UNITED STATES DEPARTMENT OF COMMERCE United States Patent and Trademark Office Address: COMMISSIONER FOR PATENTS P.O. Box 1450 Alexandria, Virginia 22313-1450 www.uspto.gov

APPLICATION NO.	FILING DATE	FIRST NAMED INVENTOR	ATTORNEY DOCKET NO.	CONFIRMATION NO.	
10/587,152	07/25/2006	Walter Stieglbauer	STIEGLBAUER ET AL 6 PCT	4971	
25889 COLLARD & I	7590 07/13/2011 ROE, P.C.	1	EXAMINER		
1077 NORTHE	RN BOULEVARD		DANG, KET D		
ROSLYN, NY	11370		ART UNIT	PAPER NUMBER	
			3742		
			MAIL DATE	DELIVERY MODE	
			07/13/2011	PAPER

DETAILED ACTION

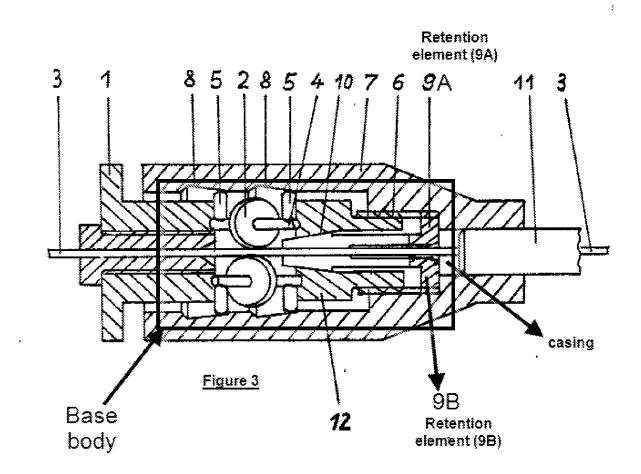
7. Regarding claims 61, 83, 86, 89, 91, 93, and 94, Berger discloses a method for feeding a welding wire 3 (Fig. 10 from a wire storage to a point of consumption, wherein a plurality of guiding elements 5 (Fig. 1) for guiding the welding wire 3 (fig. 1) are arranged in a base body (see figure 3 below), wherein the guiding elements 5 (Fig. 1) and the base body are arranged in a drive sleeve 7 (Fig. 1) to form a drive mechanism connected with at least one transport element 2 (Fig. 1) of each guiding element 5 (Fig. 1), the method comprising the following steps: guiding a welding wire through at least one guide element 2 (Fig. 1), contacting said welding wire at least one transport element 2 (Fig.1) on a side of the respective guiding element facing the welding wire 3 (Fig. 1), wherein said at least one transport element is shaped as a ball (page 3, lines 49-56); displacing at least one further transport element via a drive mechanism 7 (Fig. 1) on at least one further side of the guiding element 5 (Fig. 1, the bottom side), thus causing the transport elements 2 (Fig. 1) arranged in the guide path to be moved on by said at least one further transport element displaced by the drive mechanism 7 (Fig. 1), and displacing at least one guiding element for adaptation to the diameter of the welding wire (Abstract recites "the diameter of a wire nozzle bore is automatically adjusted along with roller adjustment").

(abstract): a plurality of guiding elements 5 (Fig. 1) for guiding the welding wire 3 (Fig. 1), a base body (see figure 3 above); and a drive sleeve 7 (Fig. 1) connected with at least one transport element of each guiding element; wherein at least one further transport element 2 (Fig. 1) is connected with the welding wire 3 (Fig. 1) in at least one of a force-locking manner and a form-locking manner (Page 1, lines 84-86) (Page 2, lines 100-107); wherein the base body (see figure 3 below) and the guiding elements 5 (Fig. 1) are arranged in the drive sleeve 7 (Fig. 1); and wherein at least one guiding element 5 (Fig. 1) is displaceably arranged to adapt to a diameter of the welding wire (Abstract recites "the diameter of a wire nozzle bore is automatically adjusted along with roller adjustment").

With respect to claims 42, 50-51, 55, 59, 70-71, 75, 79, 85, and 88, Berger discloses wherein at least one guiding element is displaceably arranged in a base body (See annotated "Base body" in figure 3 above); the positioning flange is connected with a retention element in a torque proof manner 9A (See annotated Figure 3 above); wherein the drive sleeve is connected with a coupling element, coupling element being arranged on the opposite side of the retention element 9B (See annotated Figure 3 above); wherein the drive is rotationally connected with a further retention element (See annotated Figure 3 above for retention elements); wherein the drive sleeve has an outer diameter of between 20 mm and 30 mm (Abstract, variable diameter).
